Project: PA6940
Current Revision: R1M0E1

PA6940 Revision History:

M8 to OAK

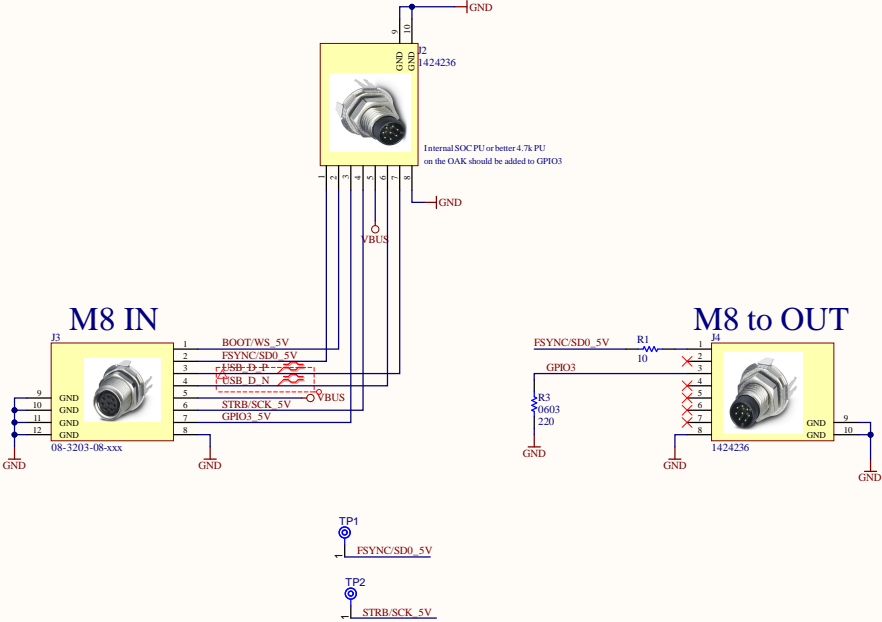
| Date | Revision | Reason for Change | Changes Implemented |
|--------------------|----------|---|--|
| 13th of June 2023 | R1M0E1 | Connector that connects to device was not mirrored (CONNECTOR J2). J4 CONNECTOR OUT: - STRB deleted - GPIO3 moved to pin 3 - FSYNC moved to pin 1 - Changed R1 from 0 ohm to 10 ohms | - STROBE connection removed from male connector connecting slave devices - GPIO3 moved to pin 3 - FSYNC moved to pin 1 - Changed R1 from 0 ohm to 10 ohms |
